# City of Corpus Christi

## Meeting Agenda Planning Commission

Wednesday, September 2, 2020

**TECHNICAL REVIEW PLAT REQUIREMENTS  
REGULAR PLANNING COMMISSION MEETING  
SEPTEMBER 2, 2020**

**SWQMP - GEMINI ACRES**  
A 312.904 ACRE PORTION, MORE OR LESS, OF SECTION 2,  
LAURELES FARM TRACTS, A MAP OF WHICH IS RECORDED IN  
VOLUME 3, PAGE 15, MAP RECORDS, NUECES COUNTY, TX  
NUECES CO., TX

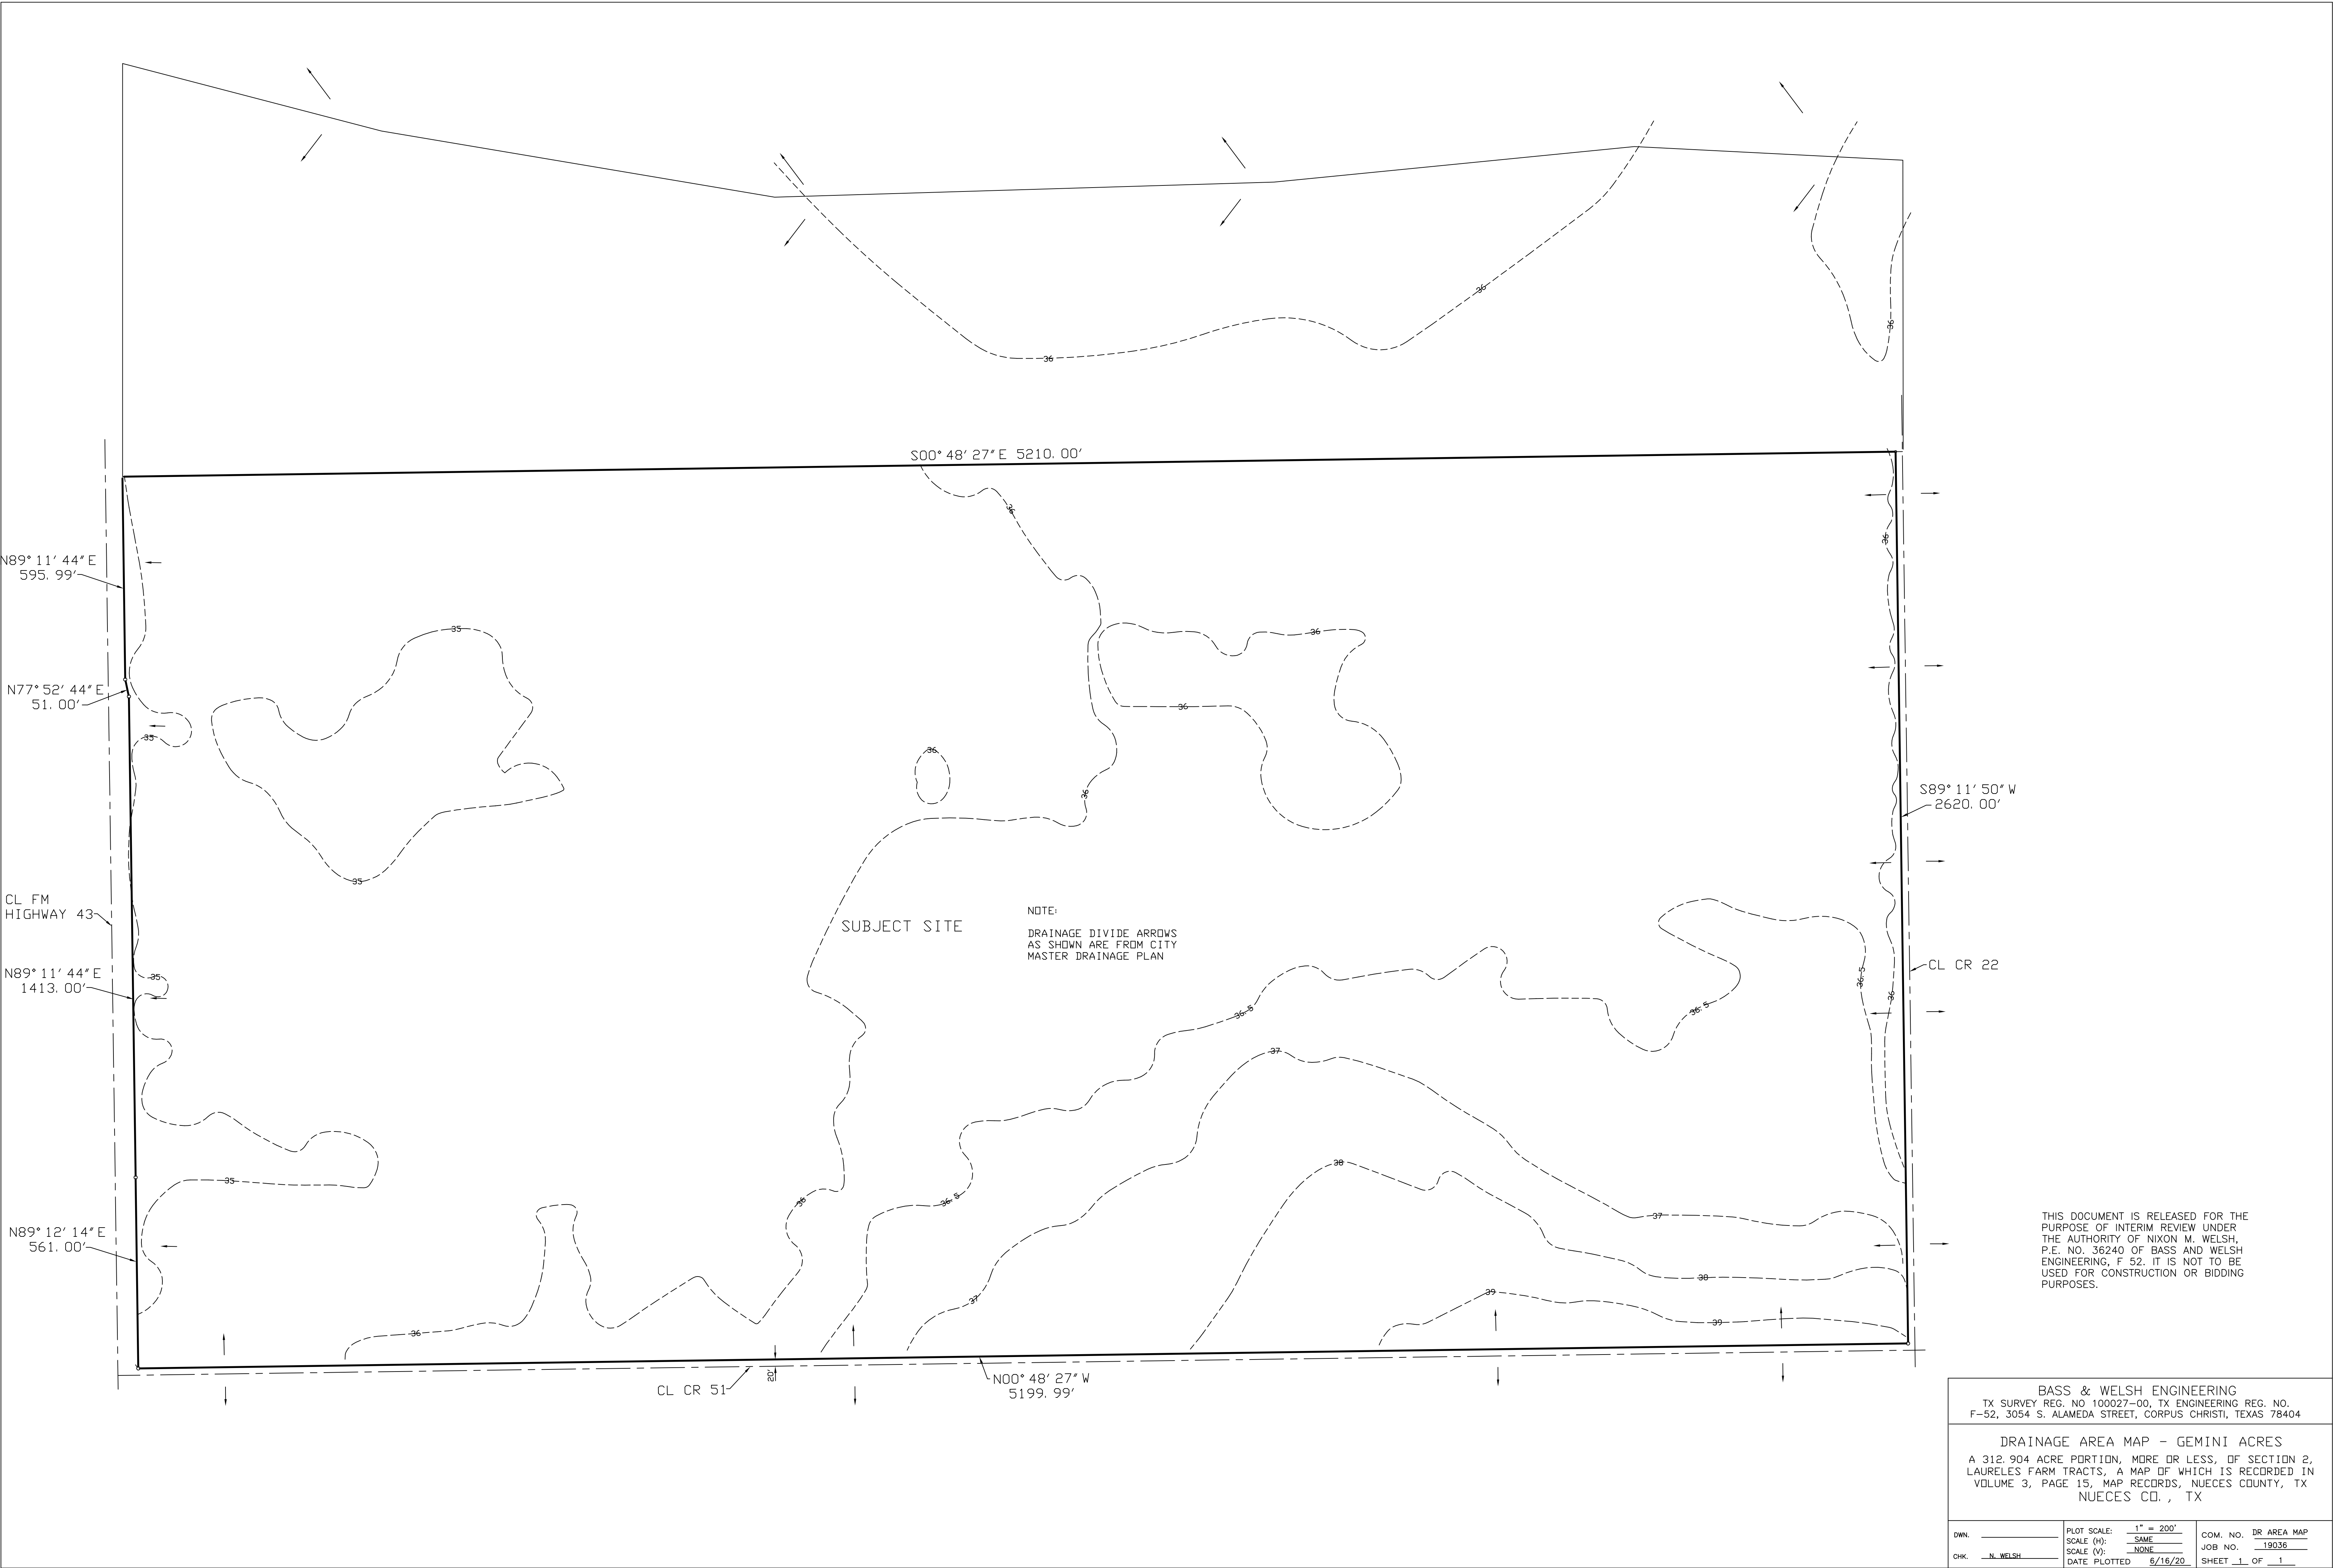
31	SWQMP	Follow the most current TxDot rainfall intensity calculations for rainfall run-off.	Done.	Not addressed.	Done. Used TP 40	Addressed.
32	SWQMP	Change the cross-slope to 4:1 for the typical detention basin at FM 43.	Desire 2:1 so lake boundaries will change less with rise/fall lakes for detention	Not addressed.	Desire 2:1 so lake boundaries will change less with rise/fall lakes for detention. Ok according to virtual meeting 8-6-20	To be determined with TxDot review.
33	SWQMP	How will run-off to and from this development be affected, provide wider range study. Consult the City of Corpus Christi Master Drainage plan for drainage channels along the east and north along FM 763.	Drainage areas follow closely city's master drainage plan	Not addressed. Add drainage areas.	Drainage areas follow closely city's master drainage plan. Ok according to virtual meeting 8-6-20	Addressed.
34	Water Plan	Add note: The placement of utility lines within the road right of way shall conform with the Nueces County Accommodations of Utility Line Facilities within County Right of Way.	Done.	Addressed.

35	SWQMP	Add Lot 1, Block 4 to Note 22.			Done on preliminary Plat	Addressed.
36	SWQMP	Verify the hydrology parameters for the developed run-off, provide calculations.			Done.	Addressed.
37	SWQMP	No detention will be allowed within the road right of way of this development.			Disagree. Roadside ditches will be higher than detention basins. Will show in construction plans.	To be addressed on Final Plat.
38	SWQMP	Add water surface elevations for 5, 10, 25 & 100 year storms on the basin/lakes.			Added for 100 year storm. See typical section detention basin	The normal water surface on the basin/lake sections do not match. Corrected to Match. County is fine with responses.
39	SWQMP	Provide calculations for CW coefficient and time of concentration.			undeveloped c = 0.2. developed c = 0.4, TC both 90 min	Addressed.
40	SWQMP	Is the normal water surface on the basin/lake sections for retention? Explain.			detention is provide by 1.5' rise in water surface. See typical section	The normal water surface on the basin/lake sections do not match; are these for 5, 10, 25 or 100 year flood? Corrected to match. For 100 yr flood. County is fine with responses.

41	SWQMP	Txdot comments have not been submitted, we may have further comments.			Ok	County is fine with responses.
42	SWQMP	Add Q value at the 3x8 box culvert under FM 43.				This is already shown (428 CFS). County is fine with responses.
43	SWQMP	Preliminary plat will be conditionally approved once these comments are addressed, pending review of public infrastructure plans.				OK. County is fine with responses.

OWN.	PLOT SCALE: 1" = 200'	COM. NO.	PREL AS WTR
CHK.	SCALE (H): SAME	JOB NO.	19036
	SCALE (V): NONE		
	DATE PLOTTED 8/14/20	SHEET 1 OF 1

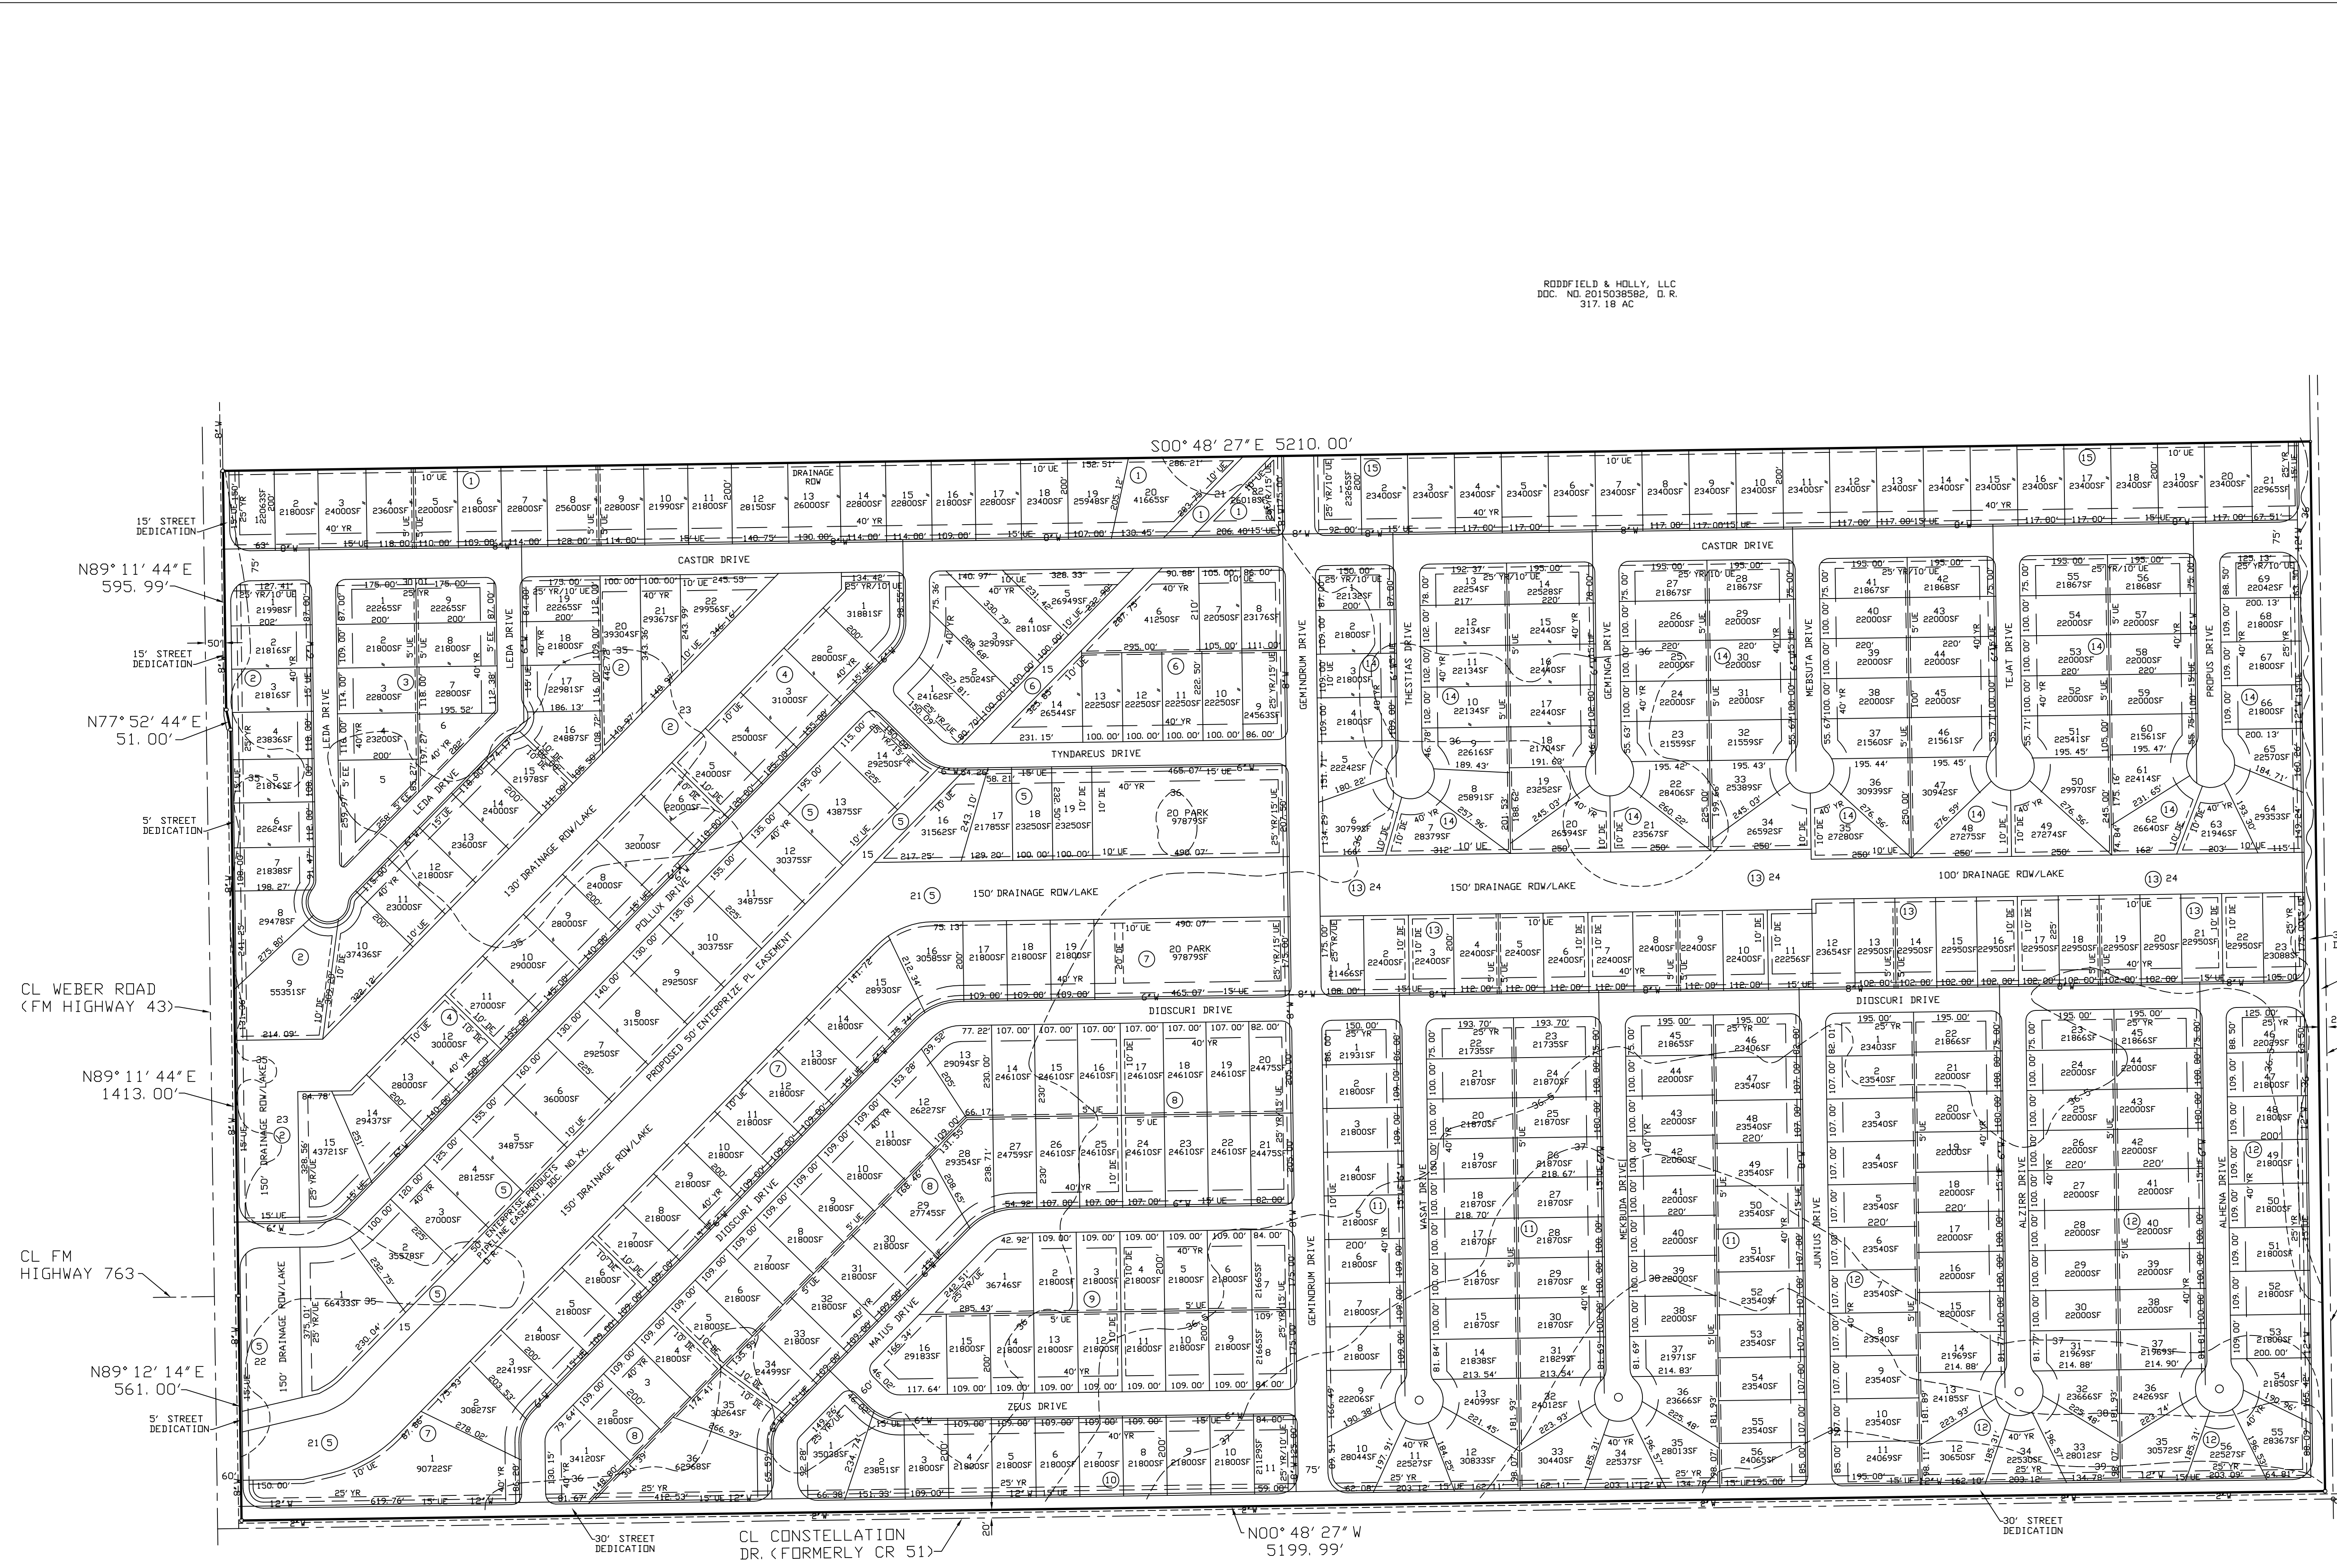
25	Plat	A Water Service Agreement will be required and filed for record with the final plat.	OK.	To be addressed on Final Plat.		
25A	Plat	The unpaved portion of County Road 22 that fronts the development will have to be constructed to meet county specifications.				Not addressed. CR 22 is to be paved SH286 to CR 51 long before we plat along CR 22. County is fine with responses.
26	SWQMP	Add driveway detail.	Done.	Not addressed.	Done.	Addressed.
27	SWQMP	Provide drainage calculations for 2/25/100-year storm.	Done.	Addressed.		
28	SWQMP	Add finished floor elevation for al lots.	Will add on final plat after construction plans are completed	Not addressed. Add notation	It was agreed in virtual meeting 8/6/20 to do on final plat	Addressed.
29	SWQMP	Add survey benchmarks (2 minimum).	Done.	Not addressed.	Done.	Addressed.
30	SWQMP	Add adjoining drainage areas.	Done.	Not addressed. Add run-off calculations	Done and OK according to virtual meeting 8/6/20	Addressed.

No.	Sheet	Comment	Applicant Response	Staff Resolution	Applicant Response	Staff Resolution
1	Plat	Water construction will be required at Final Plat. No dead-end mains will be permitted.	Ok.	Addressed.		
2	Plat	Wastewater construction will be required at Final Plat.	No waste water.	Addressed.
